**Revised Proposal of amendments to
ECE/TRANS/WP.29/GRSP/2014/11 - Draft Regulation on
electric vehicles of category L, submitted by the Informal
Working Group REESS**

**Submitted by the expert from the International Motorcycle
Manufacturers Association**

The text reproduced below was prepared by the expert from the International Motorcycles Manufacturers Association (IMMA) to introduce amendments clarifying the current text and correcting some of the text to what was agreed in the Informal Group RESS, **for discussion in 12/IWG RESS meeting.**

Figure 1

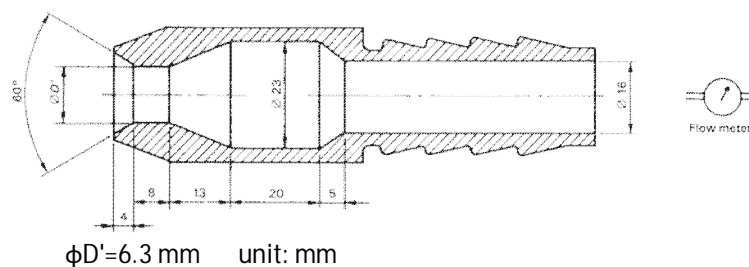
- (vii) distance from nozzle to enclosure surface: between 2.5 m and 3 m.
- (b) subsequently, apply 500V DC ~~between all the inputs and the vehicle's exposed conductive parts including the electrical chassis~~ **between all high voltage inputs and the vehicle's exposed conductive parts/electrical chassis** if present to measure the insulation resistance."

Annex 9B, para 2.

Some low voltage vehicle inputs are not directly connected to the REESS and may have a galvanic connection to the vehicle chassis (i.e. – 12V ground circuits) and should not be included in this test. The test is intended to assess protection against ingress of water and its potential effect on the High Voltage bus.
